**VILLAGE OF BARTLETT
PLAN COMMISSION
(HYBRID MEETING)
AGENDA**

**BARTLETT MUNICIPAL CENTER
228 S. MAIN STREET
November 12, 2020
7:00 P.M.**

DATE: November 6, 2020
TO: The Chairman and Members of the Plan Commission
FROM: Kristy Stone, Village Planner 
RE: **(#20-02) Rana Cold Storage**

DATE: November 6, 2020
TO: The Chairman and Members of the Plan Commission
FROM: Kristy Stone, Village Planner *KS*
RE: **(#20-08) Bucky's on Stearns**

Figure 3

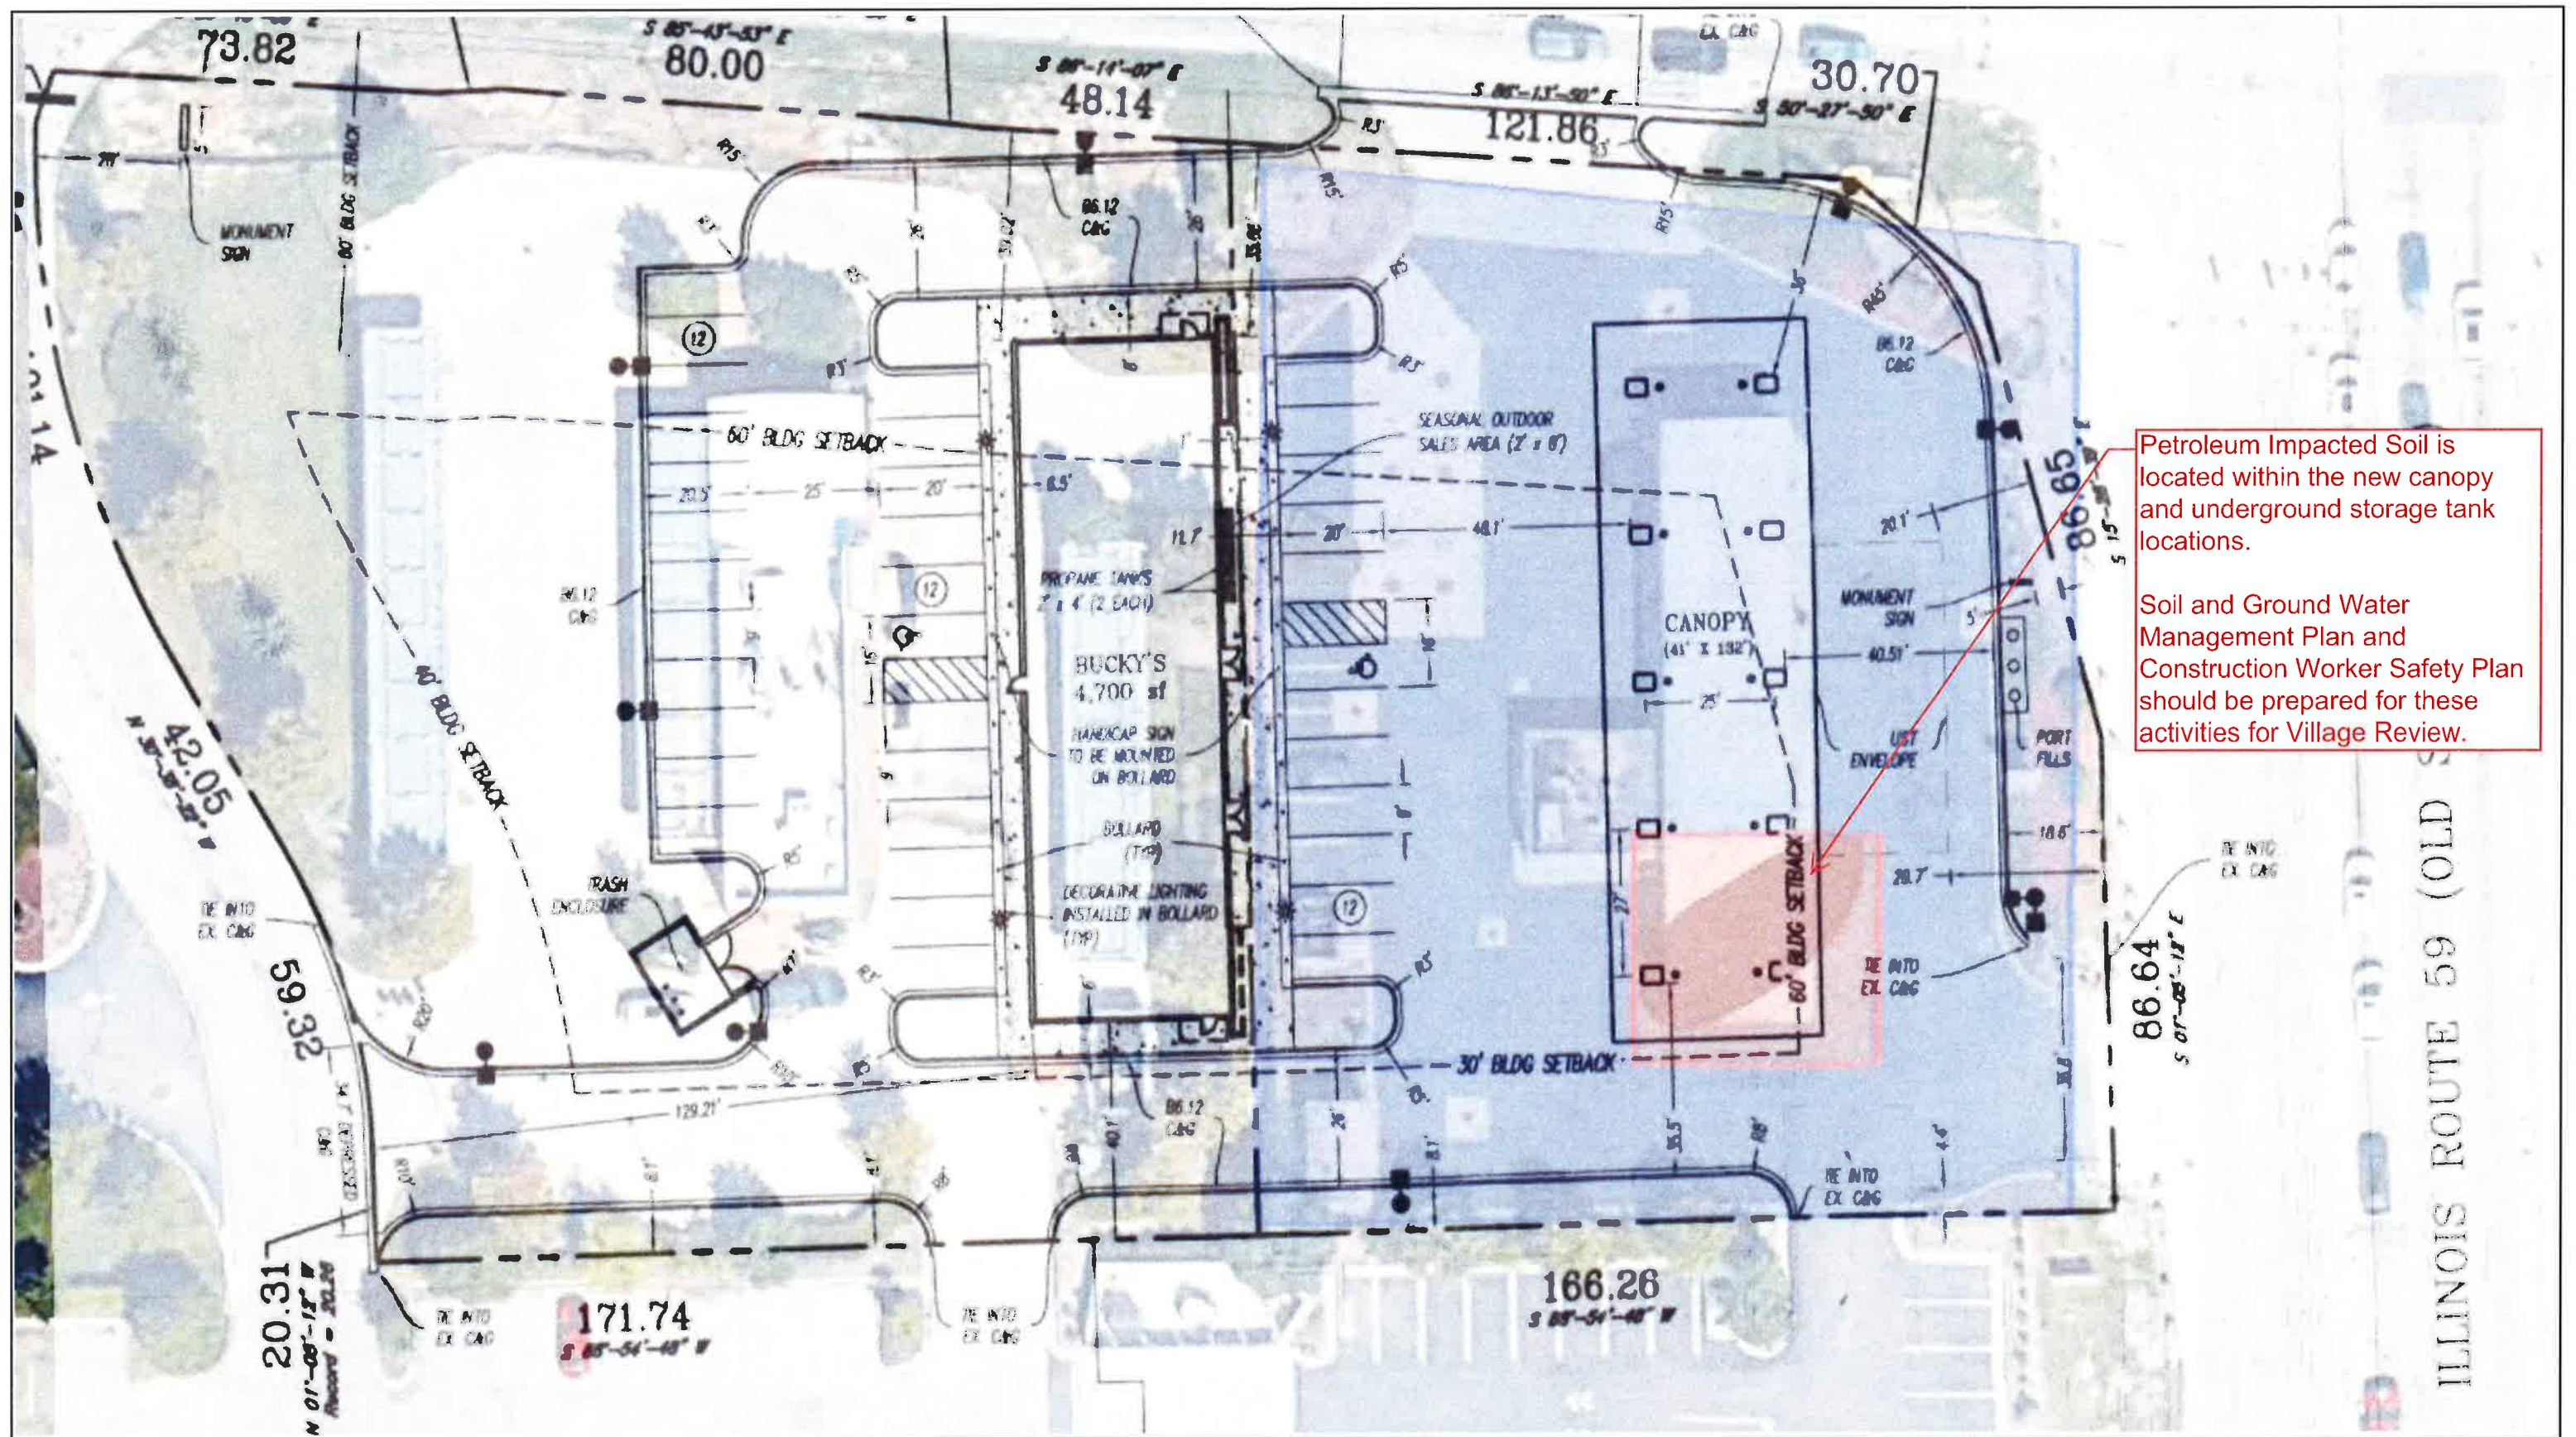
<p>According to the 2007 documentation (August 14, 2007, Corrective Action Plan), Xylenes (indicative of petroleum contamination) exceed Tier 1 Construction Worker Inhalation Remediation Objectives. We advise implementing a Soil and Groundwater Management Plan and Construction Worker Safety Plan for these demolition/removal activities and submitted for Village review.</p> <p>Depending on the excavation plan, remove and haul could be an option for contaminated soil, ultimately no longer requiring an engineered barrier (Updated NFR would be required).</p>		
<p>Utility Installation</p>	<p>Utilities leading to the new building (which are within 5 feet of the building entrance) could be a preferential pathway for vapor intrusion. The existing NFR pre-dates current regulations for protecting buildings and structures from an indoor inhalation pathway. Indoor Inhalation exposure routes should be evaluated by performing soil gas vapor sampling and analysis following IEPA protocols. Alternately, we suggest that the proposed building be designed with a vapor control building control that meets IEPA standards in 35 IAC 742.1210 (Appendix B).</p> <p>New storm water piping and canopy foundations are proposed to be constructed within the area of petroleum contaminated soil and groundwater. If feasible, we recommend that subsurface stormwater controls and structures be located outside of the boundary of petroleum contamination. If not feasible, we recommend that storm water piping and structures be designed to prevent inflow/infiltration of petroleum contaminated groundwater and vapor. One approach is to place a bentonite-mat GCL material in sewer trenches. A Soil and Groundwater Management Plan and Construction Worker Safety Plan should be prepared for these activities and submitted for Village review.</p>	<p>Refer to the Utility Plan & Site Plan, Figure 2 & Figure 3</p>
